PUBLIC NOTICE

**PROPOSED PERMIT MODIFICATION FOR THE CAMINADA HEADLANDS
BACK BARRIER MARSH CREATION PROJECT BA-171 AND BA-193 IN
LAFOURCHE PARISH**

**CAMINADA HEADLAND BACK
BARRIER MARSH CREATION PROJECT**
BA-0171
LAFOURCHE AND JEFFERSON PARISH, LOUISIANA

PERMIT MODIFICATION

PROJECT LAYOUT

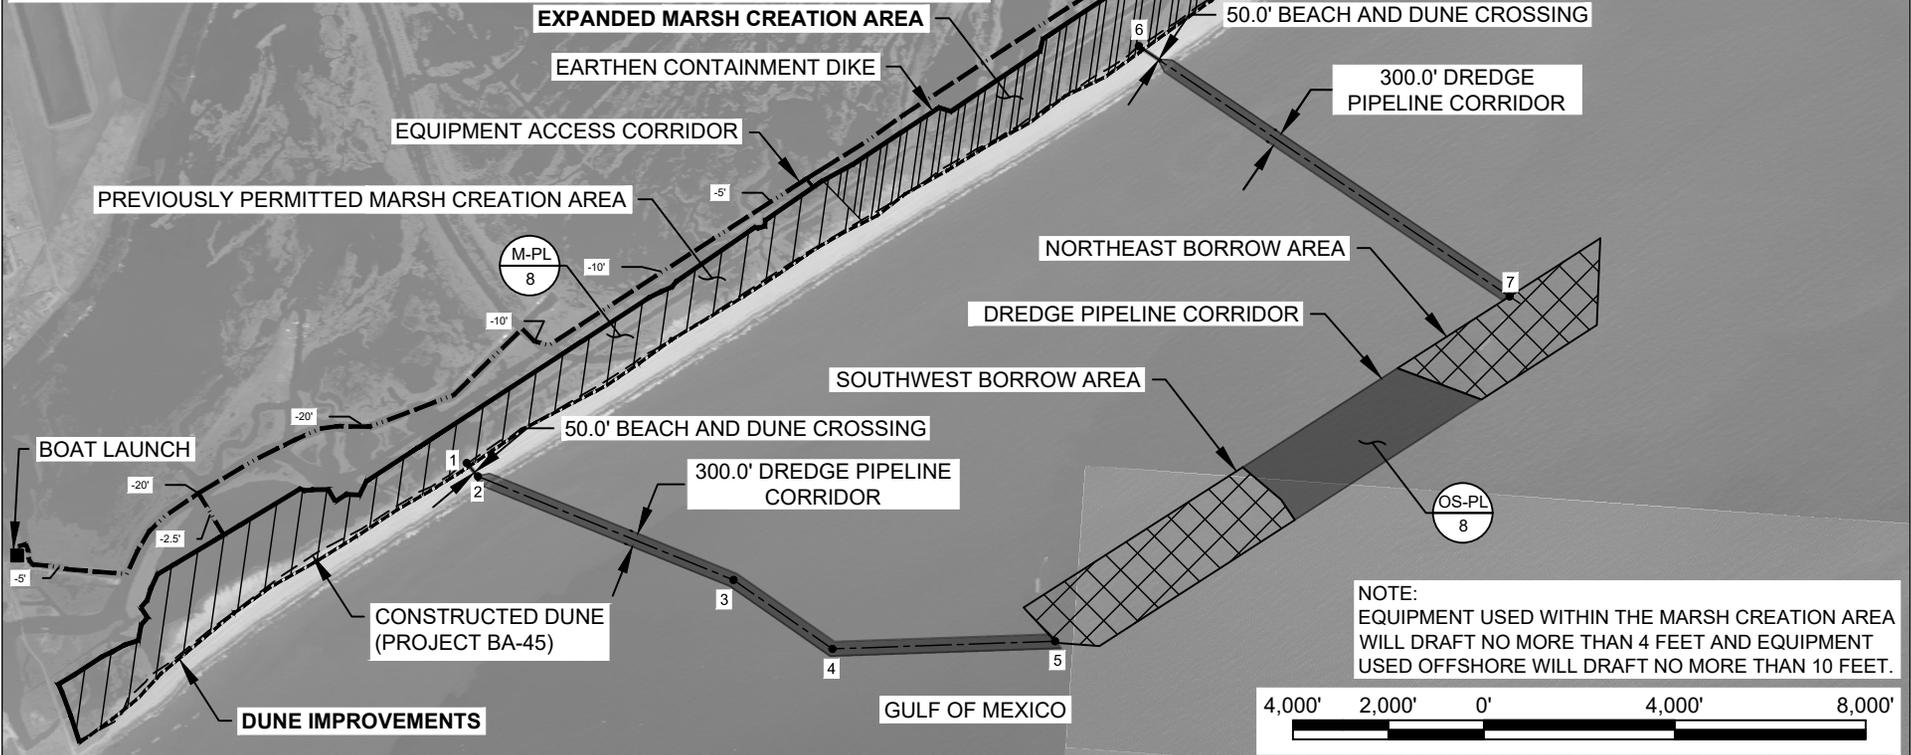
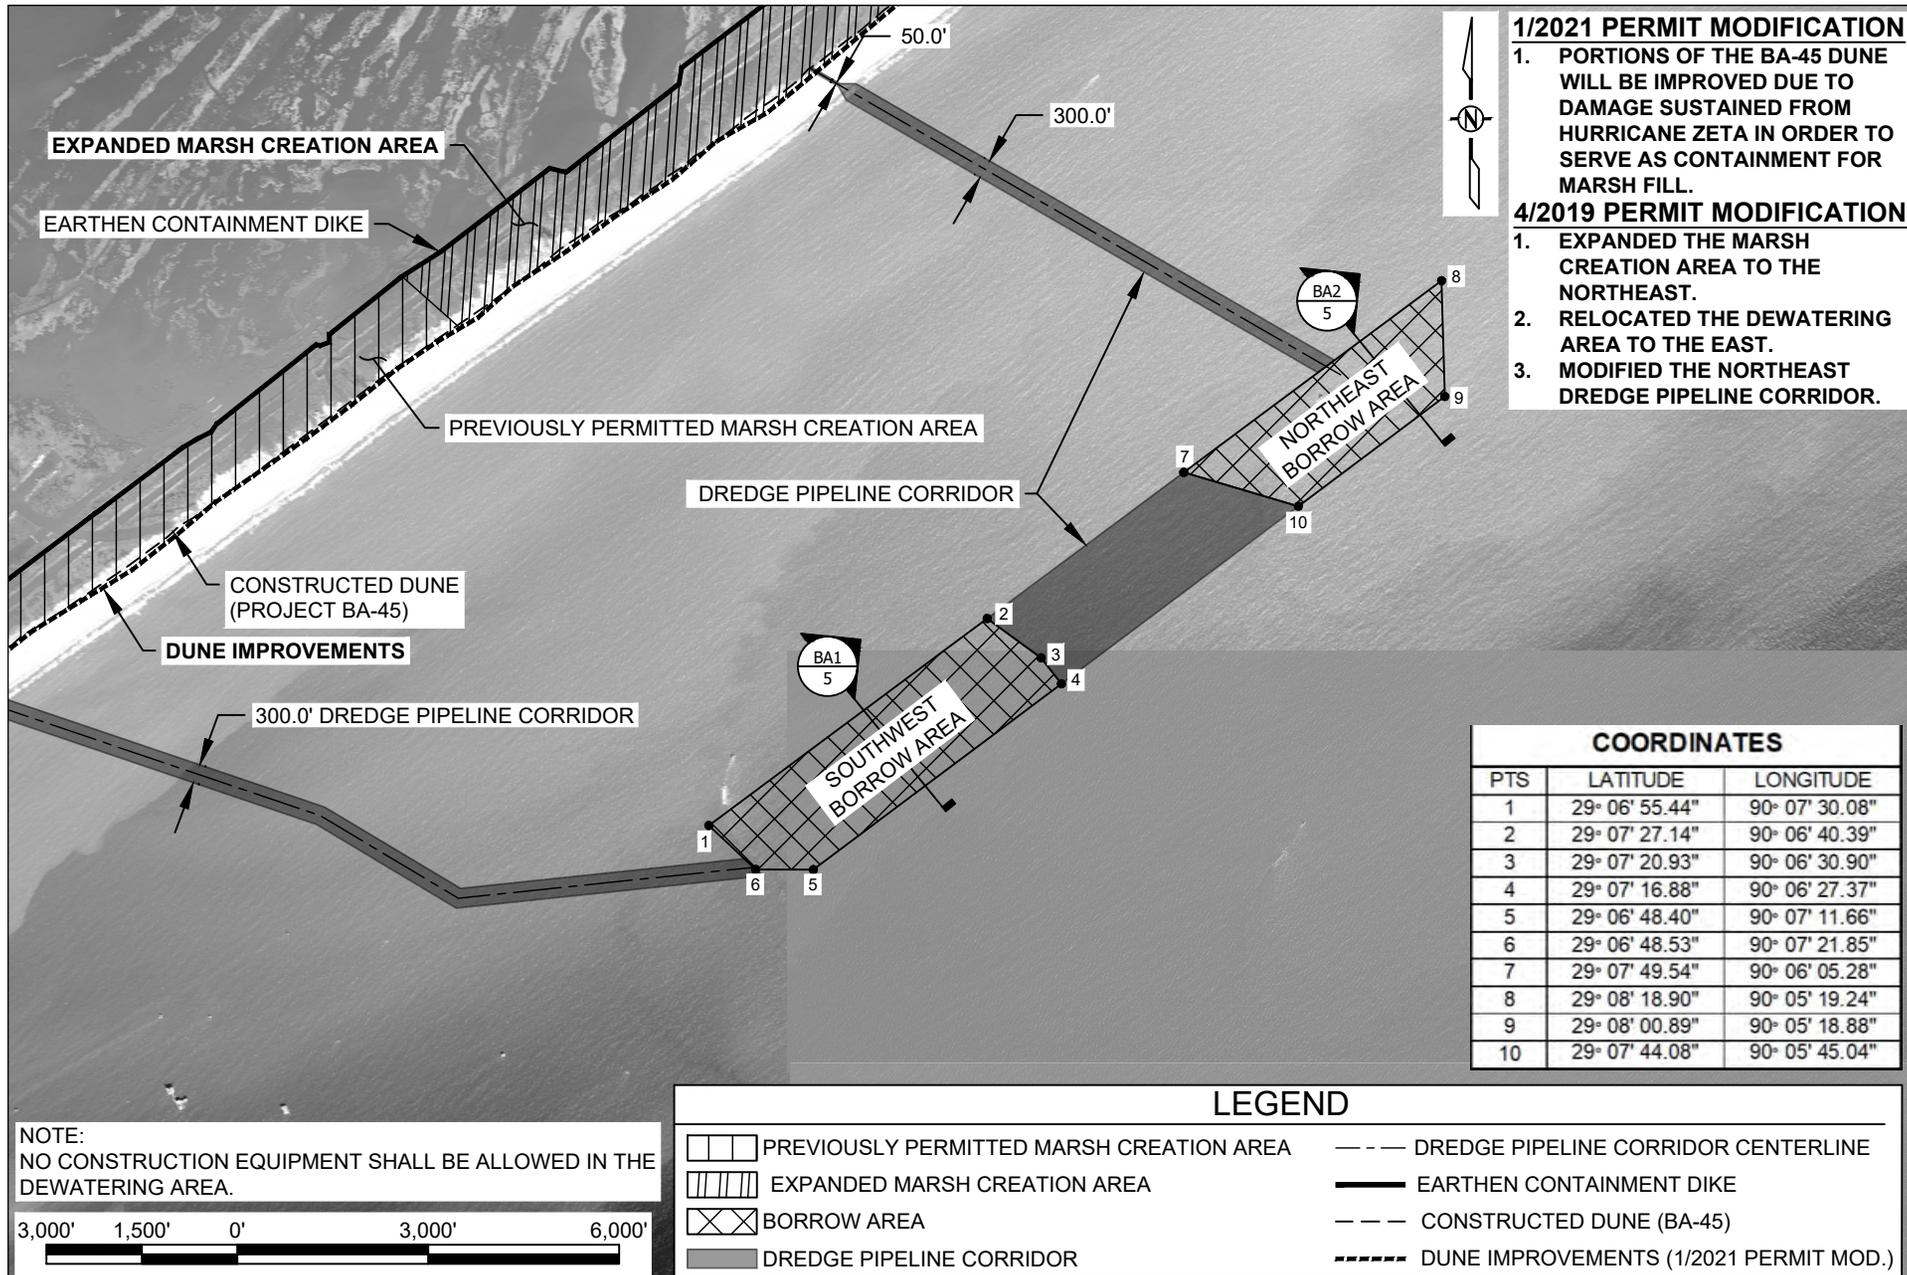
- 1/2021 PERMIT MODIFICATION**
- PORTIONS OF THE BA-45 DUNE WILL BE IMPROVED DUE TO DAMAGE SUSTAINED FROM HURRICANE ZETA IN ORDER TO SERVE AS CONTAINMENT FOR MARSH FILL.
- 4/2019 PERMIT MODIFICATION**
- EXPANDED THE MARSH CREATION AREA TO THE NORTHEAST.
 - RELOCATED THE DEWATERING AREA TO THE EAST.
 - MODIFIED THE NORTHEAST DREDGE PIPELINE CORRIDOR.

MARSH CREATION AREA LAYOUT

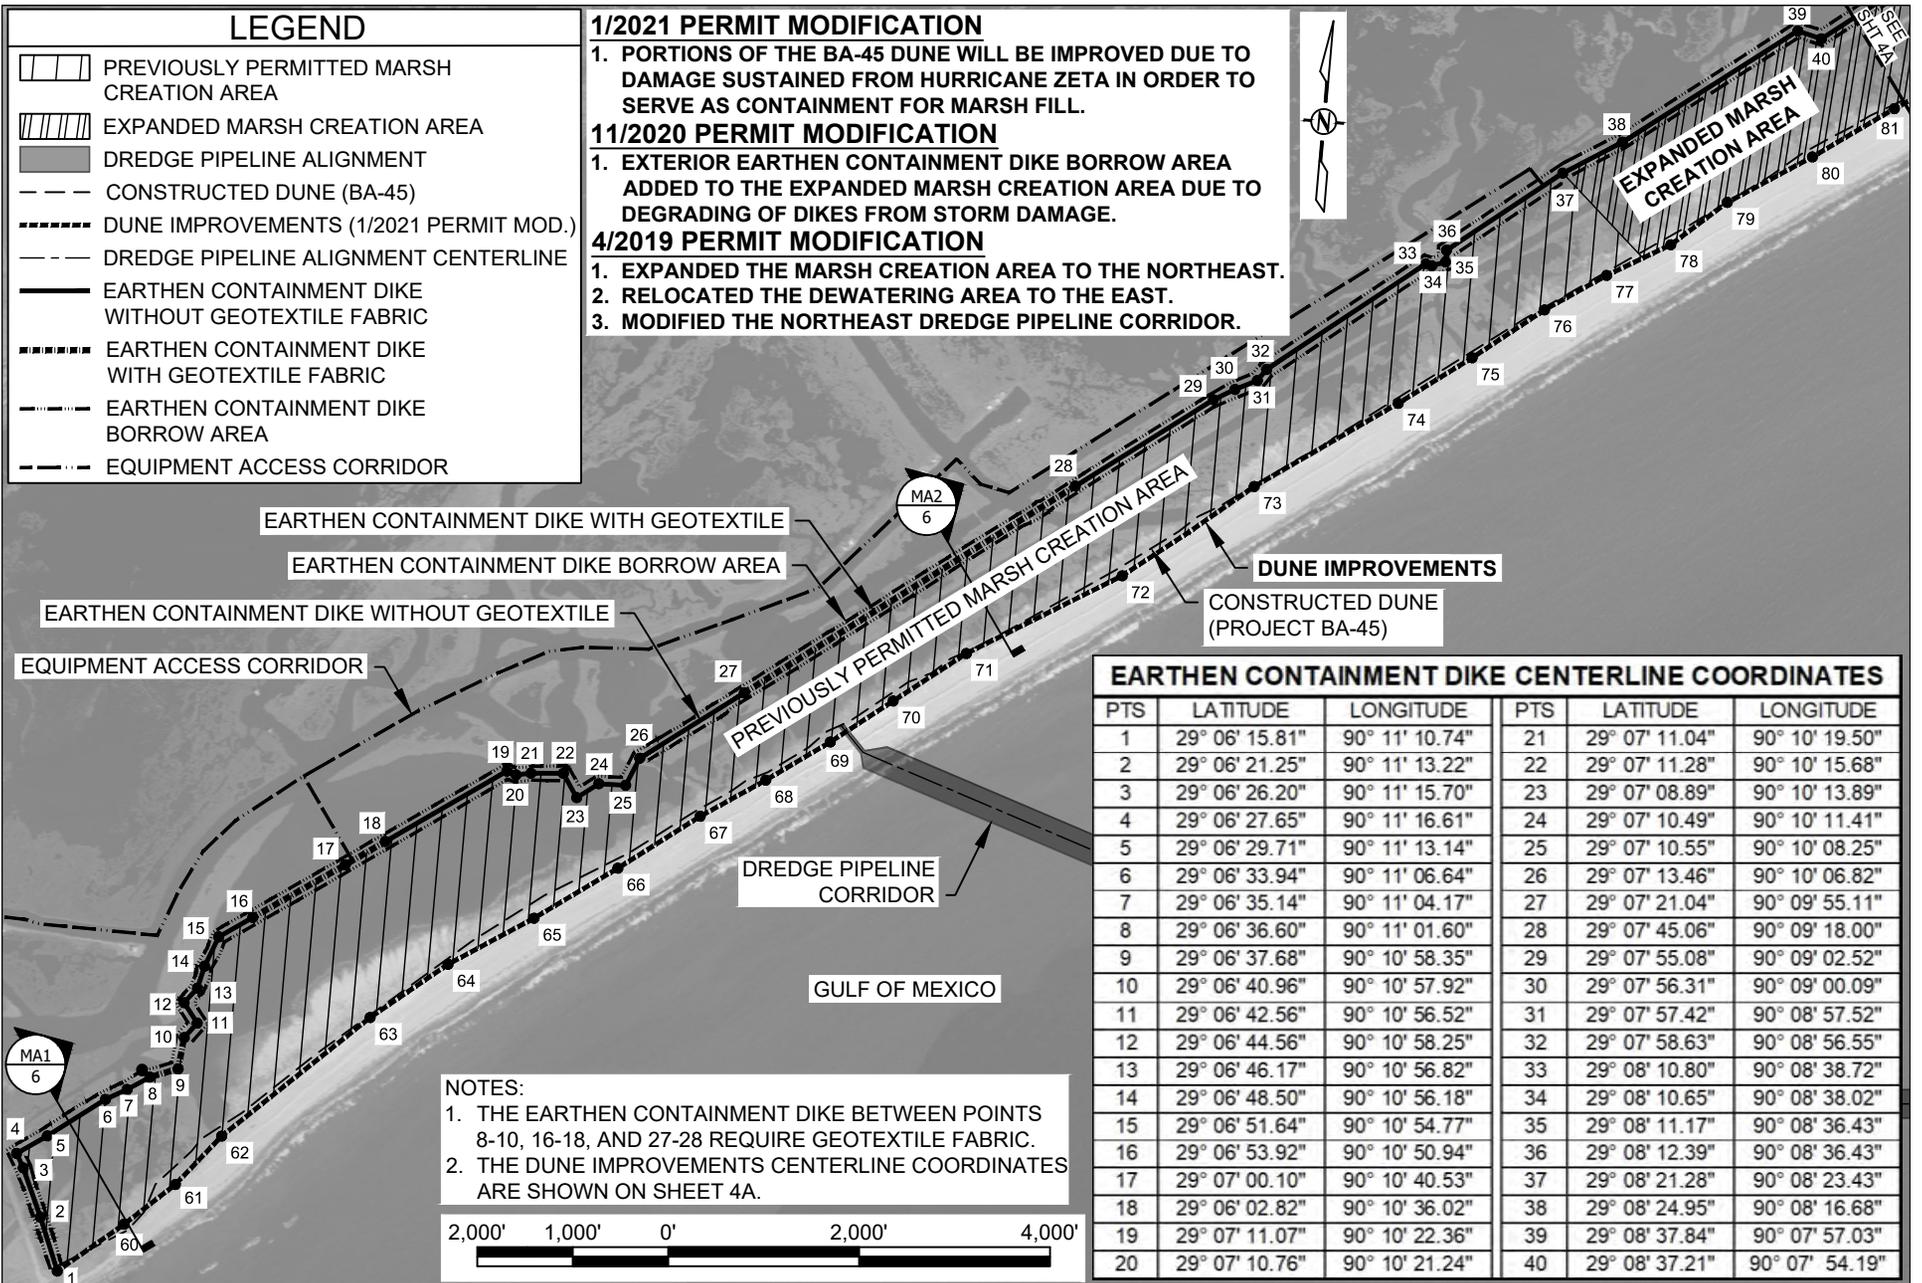
1. PORTIONS OF THE BA-45 DUNE WILL BE IMPROVED DUE TO DAMAGE SUSTAINED FROM HURRICANE ZETA IN ORDER TO SERVE AS CONTAINMENT FOR MARSH FILL.

1. EXTERIOR EARTHEN CONTAINMENT DIKE BORROW AREA ADDED TO THE EXPANDED MARSH CREATION AREA DUE TO DEGRADING OF DIKES FROM STORM DAMAGE.

1. EXPANDED THE MARSH CREATION AREA TO THE NORTHEAST.
2. RELOCATED THE DEWATERING AREA TO THE EAST.
3. MODIFIED THE NORTHEAST DREDGE PIPELINE CORRIDOR.

MARSH CREATION AREA LAYOUT

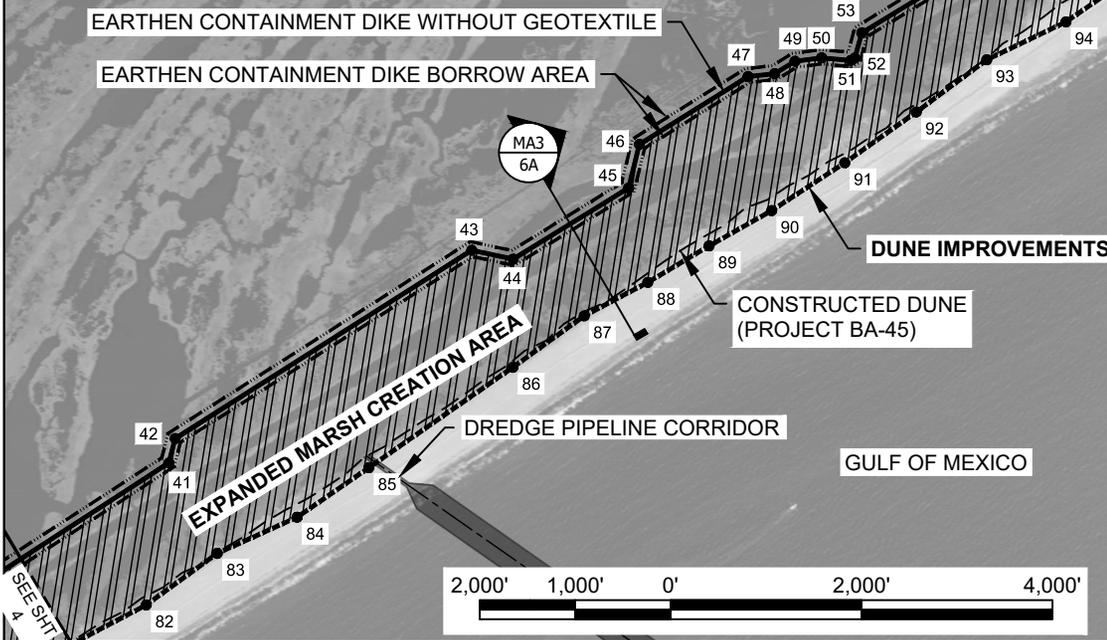
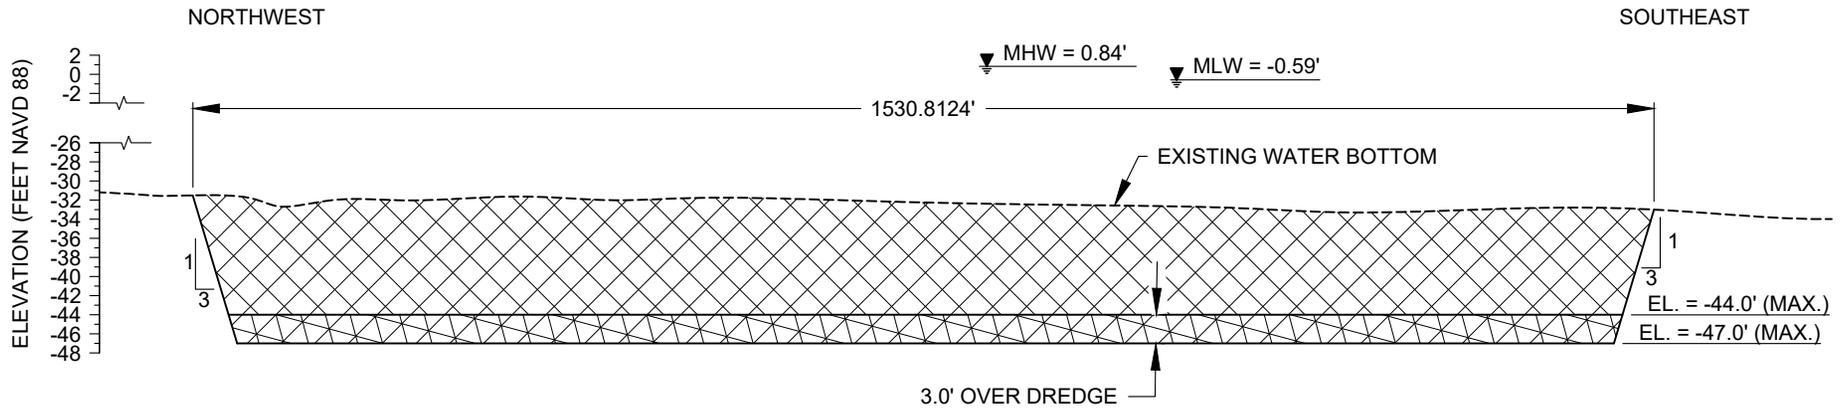
1. PORTIONS OF THE BA-45 DUNE WILL BE IMPROVED DUE TO DAMAGE SUSTAINED FROM HURRICANE ZETA IN ORDER TO SERVE AS CONTAINMENT FOR MARSH FILL.

2. EXTERIOR EARTHEN CONTAINMENT DIKE BORROW AREA ADDED TO THE EXPANDED MARSH CREATION AREA DUE TO DEGRADING OF DIKES FROM STORM DAMAGE.

3. EXPANDED THE MARSH CREATION AREA TO THE NORTHEAST.
4. RELOCATED THE DEWATERING AREA TO THE EAST.
5. MODIFIED THE NORTHEAST DREDGE PIPELINE CORRIDOR.

MARSH CREATION AREA TYPICAL SECTIONS

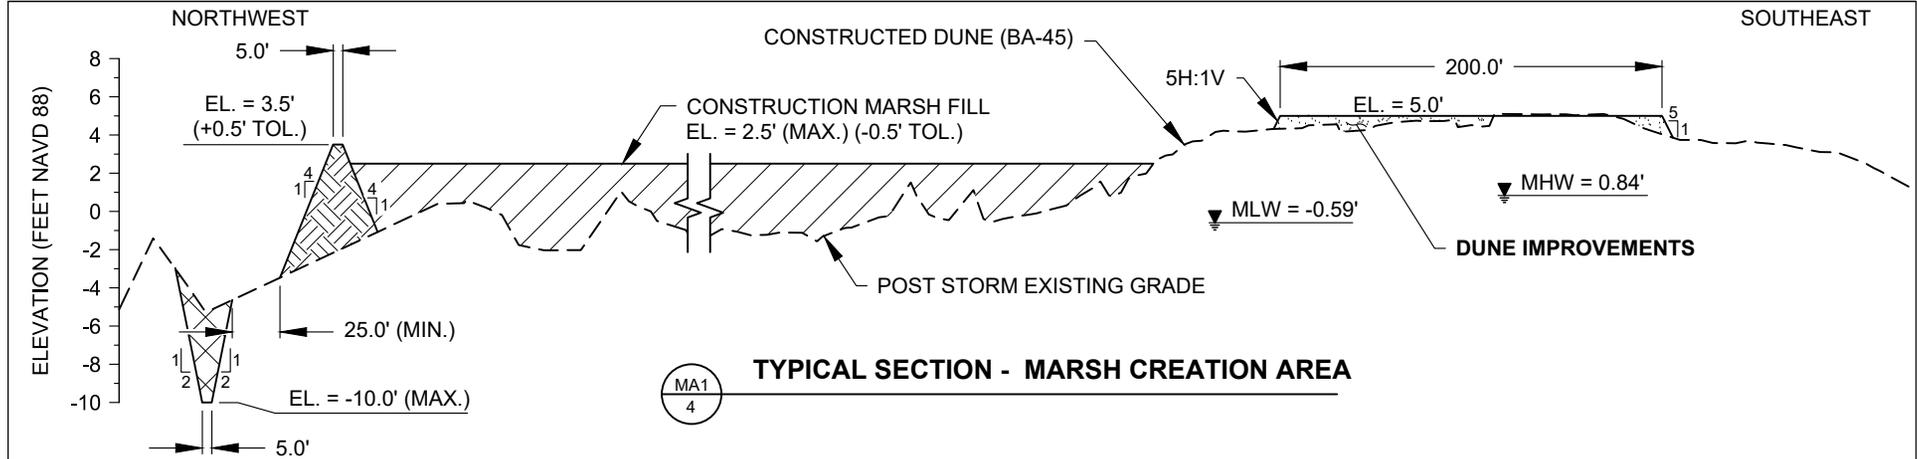
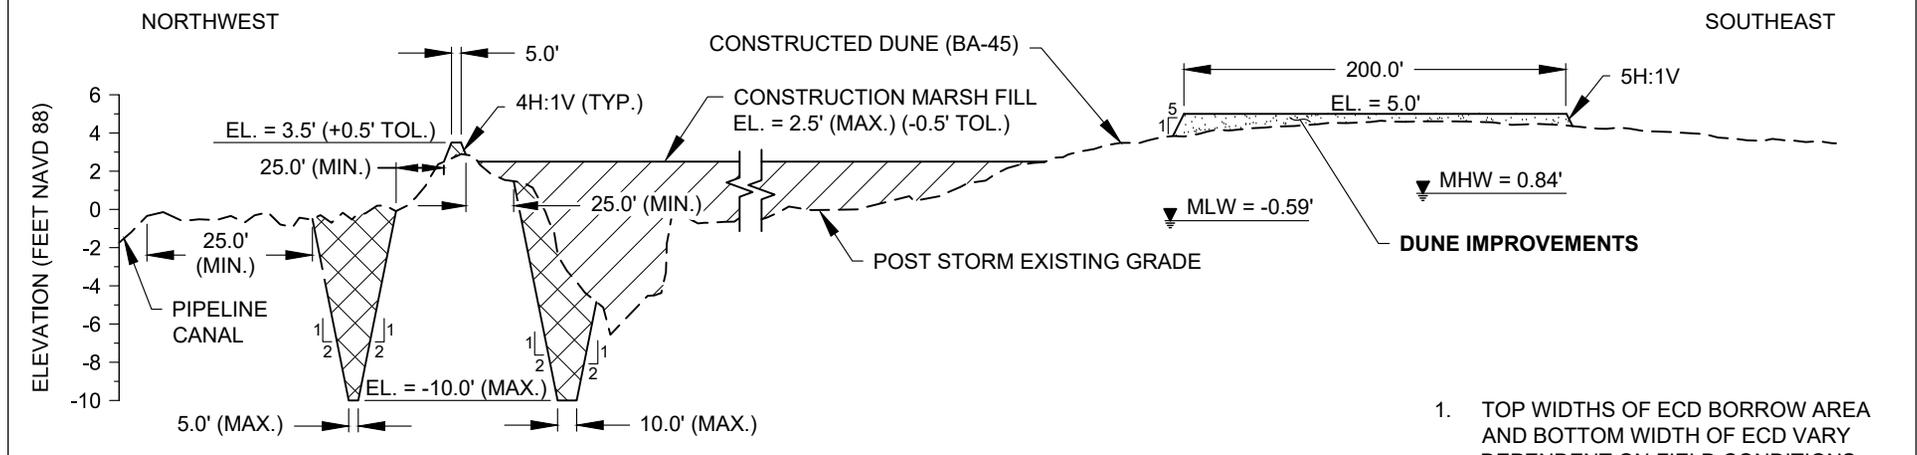
- PORTIONS OF THE BA-45 DUNE WILL BE IMPROVED DUE TO DAMAGE SUSTAINED FROM HURRICANE ZETA IN ORDER TO SERVE AS CONTAINMENT FOR MARSH FILL. SAND DISPLACED LANDWARD OF THE DUNE WILL BE UTILIZED TO IMPROVE THE DUNE.

- REVISED EARTHEN CONTAINMENT DIKE CROWN ELEVATION TO 3.5'.
- REVISED CONSTRUCTION MARSH FILL ELEVATION TO 2.5'.

MA3 4A **TYPICAL SECTION - MARSH CREATION AREA**

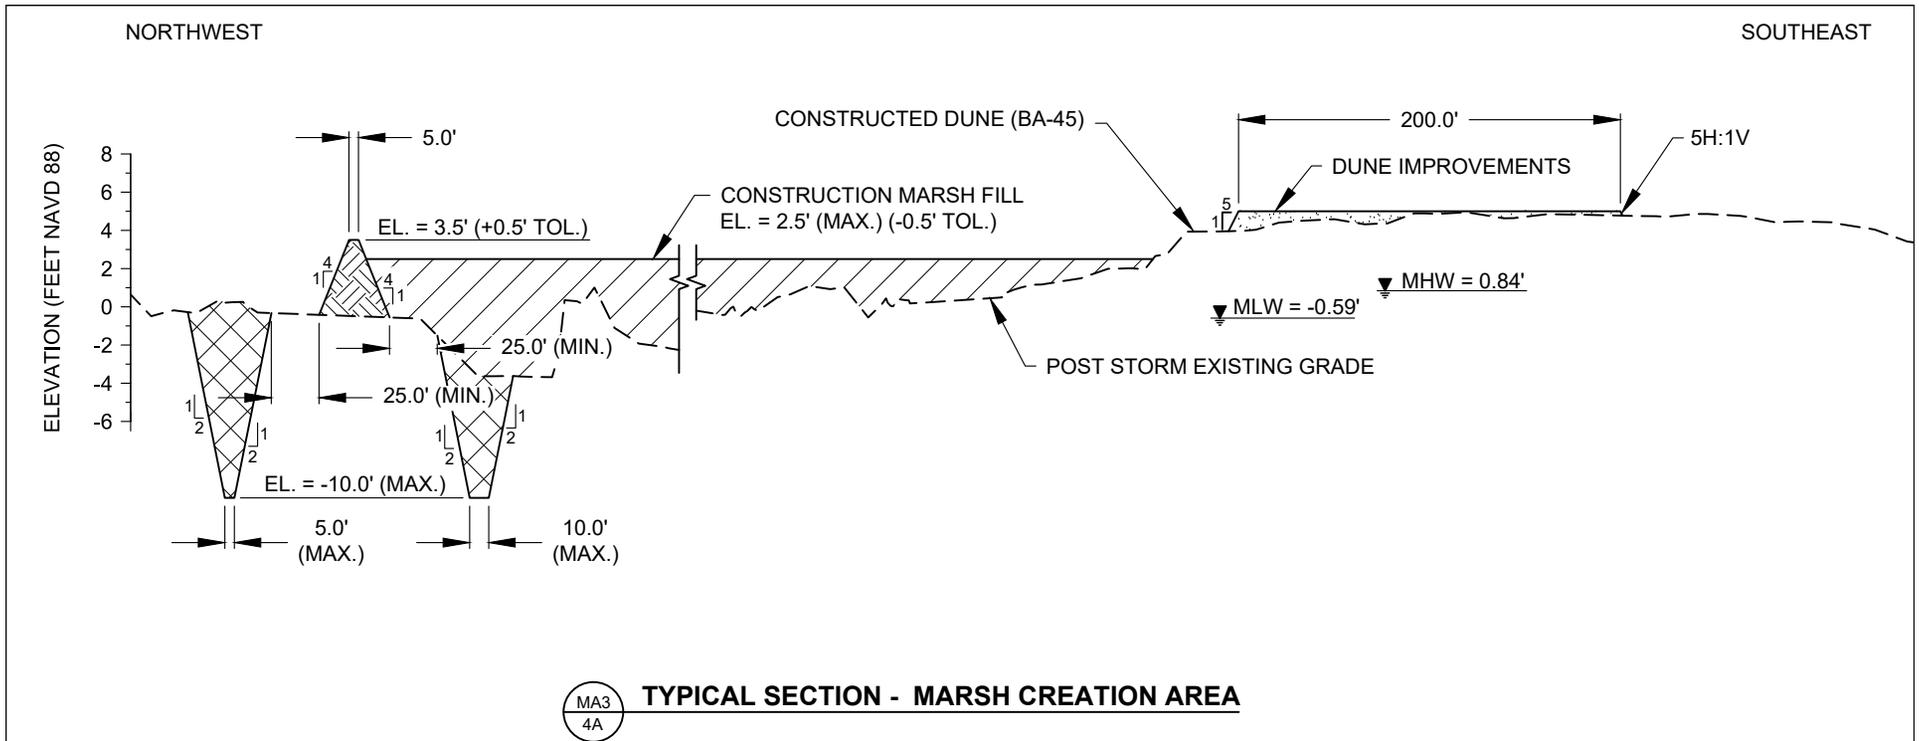
- PORTIONS OF THE BA-45 DUNE WILL BE IMPROVED DUE TO DAMAGE SUSTAINED FROM HURRICANE ZETA IN ORDER TO SERVE AS CONTAINMENT FOR MARSH FILL. SAND DISPLACED LANDWARD OF THE DUNE WILL BE UTILIZED TO IMPROVE THE DUNE.

- EXTERIOR EARTHEN CONTAINMENT DIKE BORROW AREA ADDED TO THE EXPANDED MARSH CREATION AREA DUE TO DEGRADING OF DIKES FROM STORM DAMAGE.

- TYPICAL SECTION FOR THE EXPANDED PORTION OF THE MARSH CREATION AREA.
